**Report: Deficiency Report
Function: Test, Adjust, & Balance
Date: 09/30/2025
Completed By: National TAB**

**PROJECT
09-29-25 QT #1107 ANDERSON, SC**

Issue List

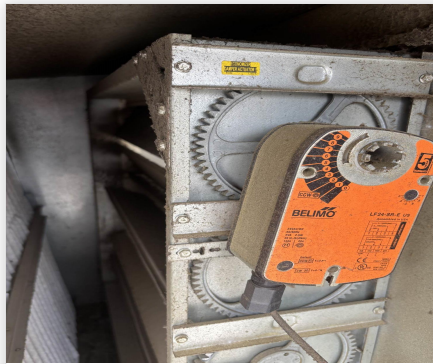
Issue Name : RTU-3 economizer doesn't close all the way
Description : The economizer on RTU 3 does not close more than 0.75". This is enough for 807 CFM of OA but does not close enough to find a set point for the 350CFM of OA also required. (Picture shows lowest set point)
Created By : National TAB **Assigned To :** National TAB - Brianna Biggs
Status : Open
Priority : Medium **Asset Tag :** RT-3
Originated Date : 09/30/2025 - Christian Moller - National TAB
